NPCC Request for Criteria Clarification

Directory 4 for Rhode Island Energy

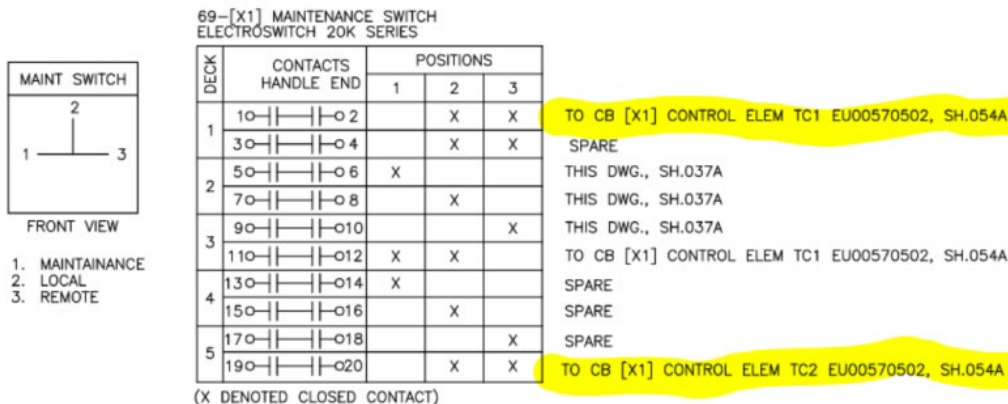
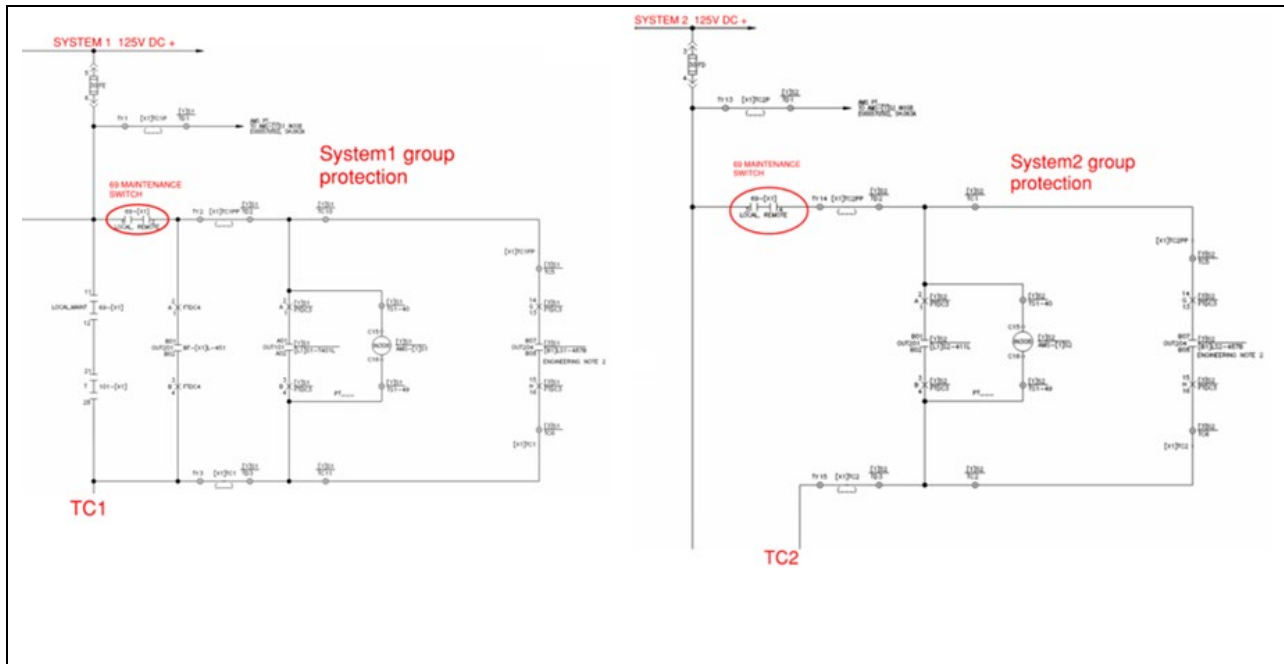
Upon reviewing, the requirement mentions that the two protection groups shall not share the same component. Reviewing the NPCC glossary of terms, component refers to the components of equipment or protection systems. Our question to the requirement is: Is this intended to address using a single protective relay/device only (where a failure of the IED device prevents operation) or does this also include mechanical devices such as control switches, lockout relay's, etc.?

PPL practice is to use a common maintenance switch to block external TRIP/CLOSE to the circuit breaker during maintenance activities only (when the circuit breaker is out of service with disconnects open). The use of a single maintenance switch is for human performance, where this switch would be mounted near the circuit breaker control switch (101 switch). The blocking of external TRIP/CLOSE operation to the circuit breaker would include blocking trips from protective relays to the breaker trip coil #1 (from system 1 relaying) and to trip coil #2 (from system #2 relaying). **These switch contacts are physically on different stacks of the maintenance switch, providing physical separation between the contacts as shown below (contact 1 & 2 on DECK 1 is for the TC1 block, whereas contact 19 & 20 on DECK 5 is for the TC2 block).**

Attached is another snapshot of the breaker trip coil circuits for trip coil #1 and trip coil #2 showing how these contacts are wired to the DC positive of the trip circuits to achieve the blocking.

These circuits are separately fused on their respective system 1 and system 2 protection panels. The switch contacts shown are dry contacts that interrupt system 1 and system 2 DC positive to the trip circuit to block relay trips during maintenance. Under normal operation, this switch would be in the 'Remote' or 'Local' position which would enable the trip circuits. This switch would only be operated for maintenance activities or switching locally.

System 1 and System 2 trip circuits shall not be connected to the same device, such as a maintenance switch, to prevent the failure of both protection systems. This requirement is applicable to maintenance switches that are located outside the breaker control cabinet.
